Memorandum

To: Carl Puzey Attn: Brad Hessing
From: Michael A. Short ^{MKS} By: Jeremy Brown
Subject: Structure Geotechnical Report Disposition *
Date: May 10, 2021

* SN: 053-2040
 Route: FAP 649 (IL 17)
 Section: (108BR-4)ES
 County: Livingston
 Contract No.: 66F92

GENERAL PLAN AND ELEVATION
 ILLINOIS ROUTE 17 OVER DRAINAGE DITCH
 F.A.P. RTE. 649 - SEC. (108BR-4)ES
 LIVINGSTON COUNTY
 STATION 510+21.00
 STRUCTURE NO. 053-2040

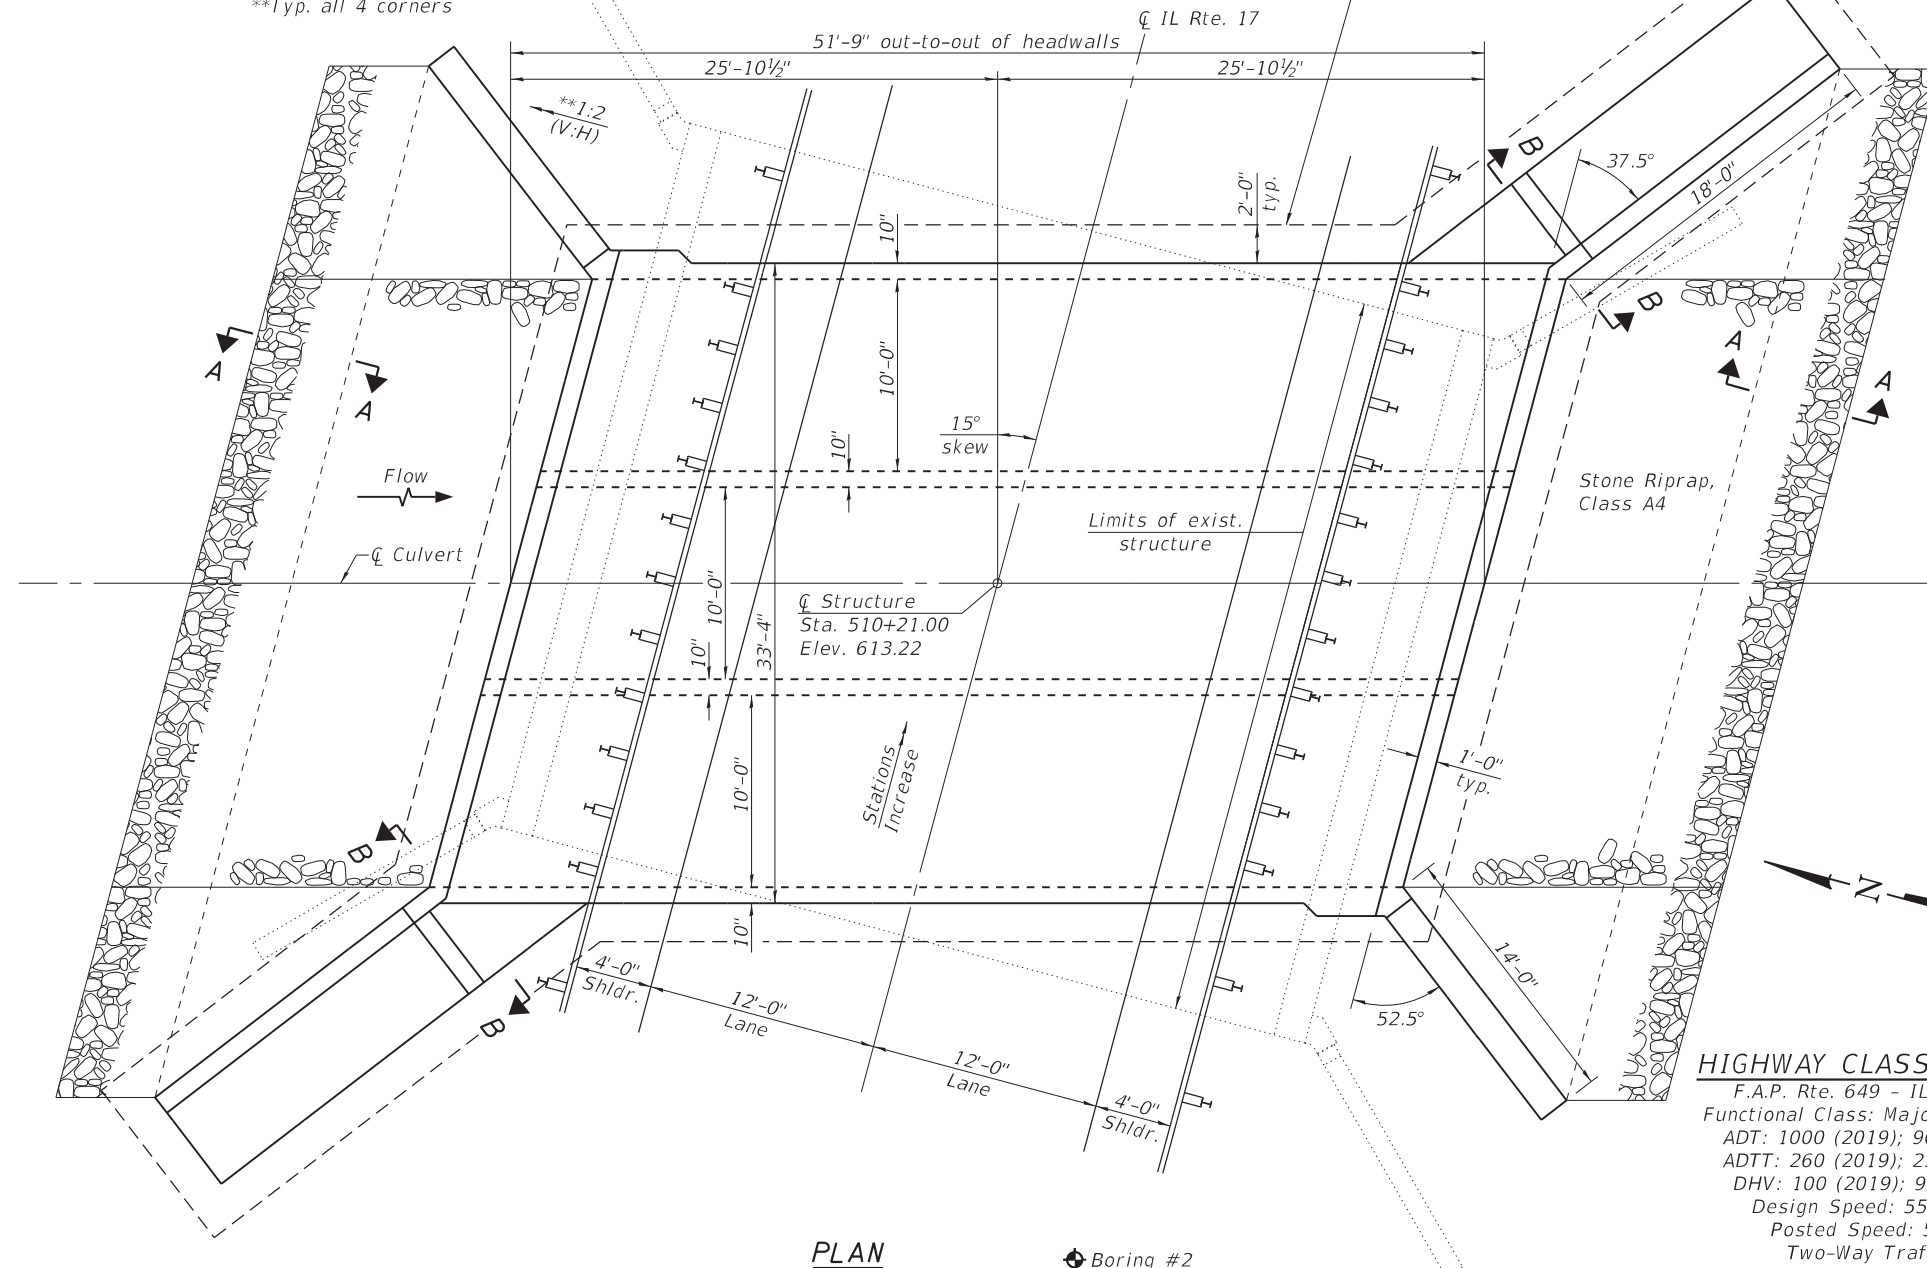
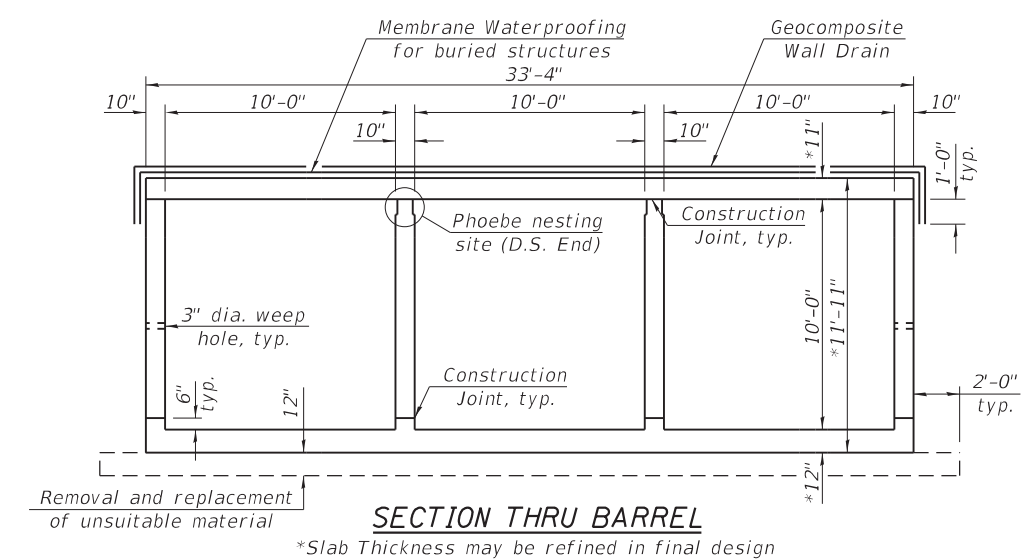
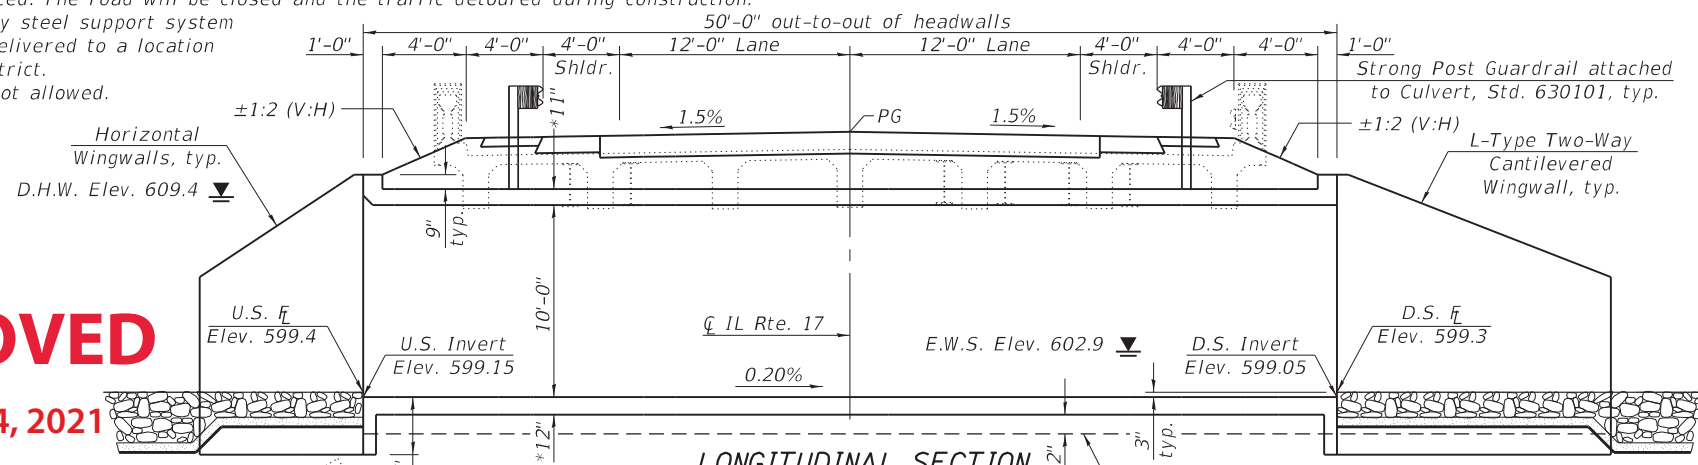
1. The 2:1 slopes shown on the TS&L are evaluated in the fill section of the revised SGR. Slope stability is not a concern due to the short height and the stability provided at the toe of the slopes by the concrete headwalls at the ends of the proposed concrete box culvert.
2. A cast-in-place concrete box culvert is recommended in the foundation section of the revised SGR due to the existing soil conditions as described in the report.
3. A 1 foot undercut below the base of the entire box culvert and two-way cantilever L-type wingwalls is recommended in the foundation section of the revised SGR per request from the Bureau of Bridges and Structures.

The fill over the top of the proposed box culvert will be approximately 3 feet high from the top of the culvert and 2 feet high from the top of the concrete headwalls and is shown to have side slopes of approximately 2H:1V on the approved TS&L. The slopes will be constructed according to section 205 of the Standard Spec Book utilizing approved materials. The slopes are relatively short in height and will also be supported at the toe by the 9 inch concrete headwalls at the ends of the box culvert. Slope stability is not a concern and no further analysis is warranted.

It is recommended by the Bureau of Bridges and Structures to remove 1 foot of material below the entire box culvert and the two-way cantilever L-type wingwalls due to the location of the existing bridge footings. The horizontal limits of this treatment shall be extended 2 feet beyond the footprint of the proposed structure. It is recommended to place 1 foot of porous granular material under the proposed box culvert as it will provide added stability and an adequate working platform for the construction process.
